Section 16 Planning Application for Proposed Temporary Warehouse  
(Storage of Timber and other Associated Materials)  
at Various Lots in D.D. 86 and D.D. 90 and Adjoining Government Land,  
Lin Ma Hang Road, Sha Ling

PLANNING CONSULTANT	
PROJECT	
PROPOSED TEMPORARY RURAL WORKSHOP (TIMBER YARD AND SAWMILL) FOR A PERIOD 3 YEARS	
SITE LOCATION	
LOT 129 (PART) IN D.D. 86, LOTS 607, 608, 609, 610 S.B RP (PART), 613 (PART), 627 (PART), 632 S.A RP, 633 S.A RP (PART), 635 S.A, 635 S.B, 635 S.C, 635 S.D, 637, 638 (PART), AND 642 S.A RP (PART), IN D.D. 90 AND ADJOINING GOVERNMENT LAND, LIN MA HANG ROAD, SAN UK LING, MAN KAM TO	
SCALE	
1 : 550 @ A3	
DRAWN BY	DATE
OL	11.03.2024
REVISED BY	DATE
APPROVED BY	DATE
DWG. TITLE	
FSIs PROPOSAL	
DWG NO.	VER.
APPENDIX I	001

<p><b>Proposed Rural Workshop (Timber Yard and Sawmill) at Various Lots in D.D.86, D.D. 90 and Adjoining Government Land, Lin Ma Hang Road, San Uk Ling, Ma Kam To</b></p>	<p><b>Proposed Temporary Storage Arrangements (Western Site)</b></p>
	<p><b>Figure 7</b></p>

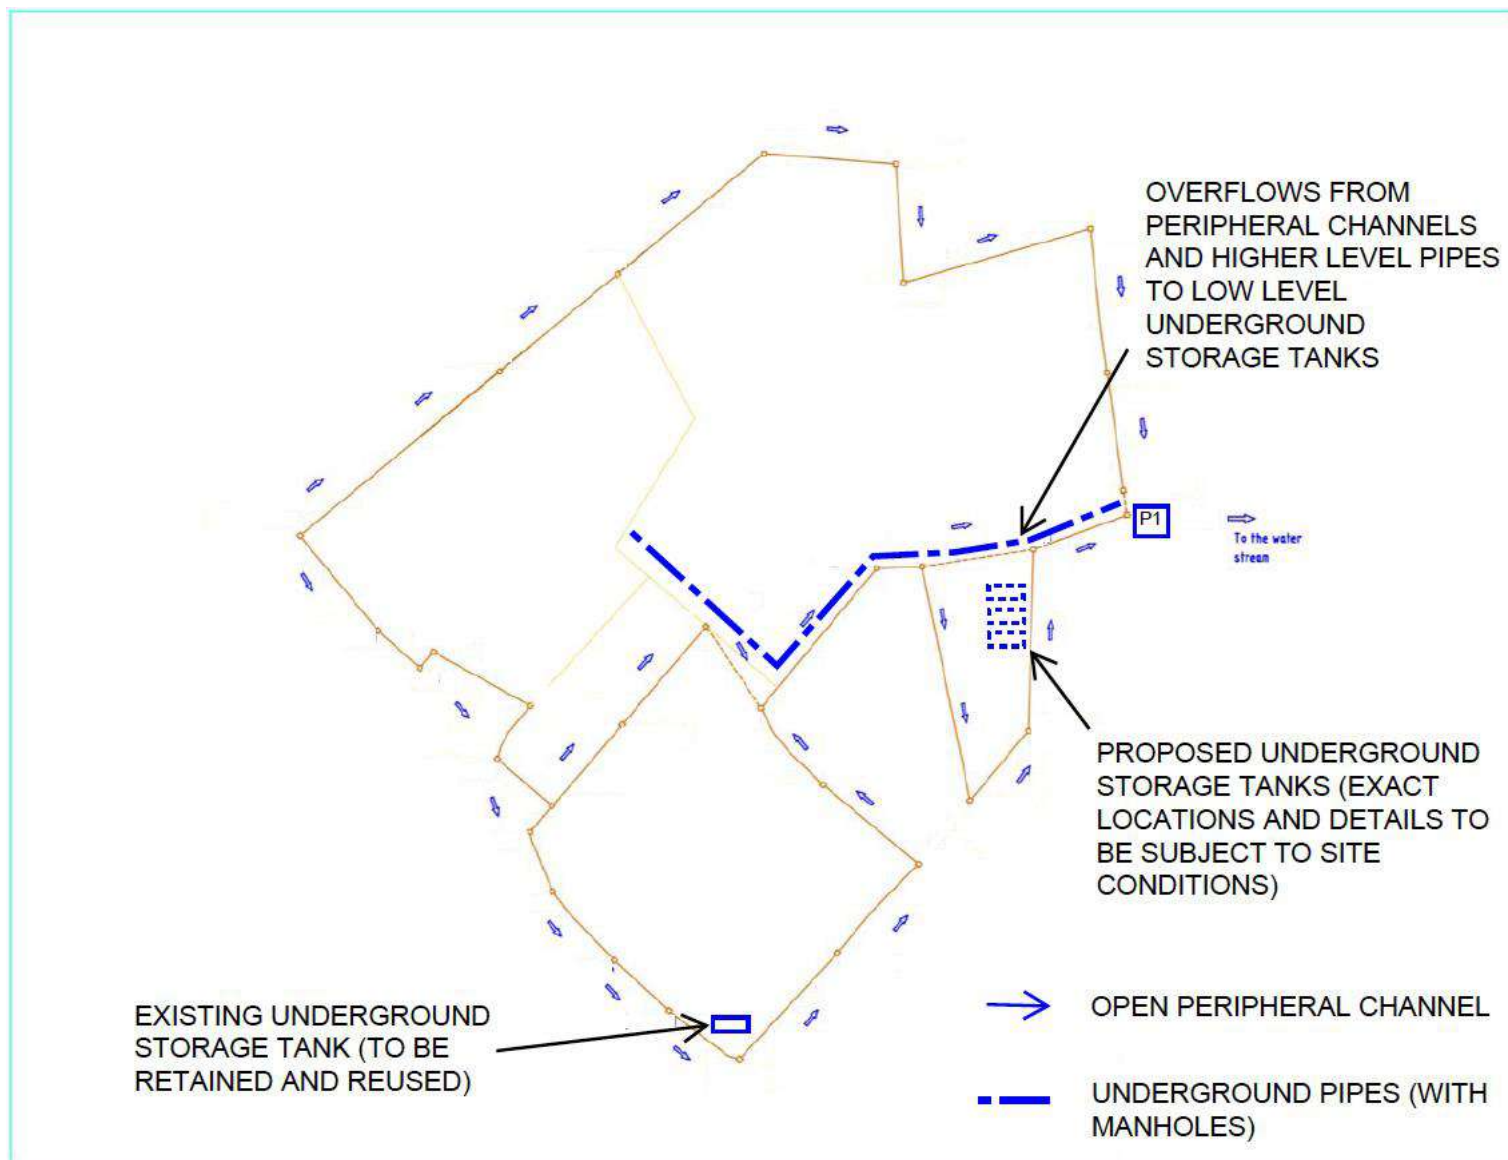
- (vi) para. 5.2.9 & Appendix G: Please provide detailed operation mechanism of the buried plastic tanks and related pumping system. It is observed from the water tank information that both the inflow and outflow are around the same level with limited size of openings, please elaborate how the pump could empty the connected plastic tanks;

DSD(3)	<ol style="list-style-type: none"> <li>3. Please provide a layout plan and schematic operation protocol to demonstrate the feasibility of the proposed use of modular storage tank on site for stormwater storage purpose.</li> </ol>	<p>The operation of the storage tanks is discussed in DIA Para <b>5.2.9</b>, i.e. weir overflows controlling the inflows and pumps to empty the tanks. A layout plan will be included as <b>Figure 7</b>.</p>
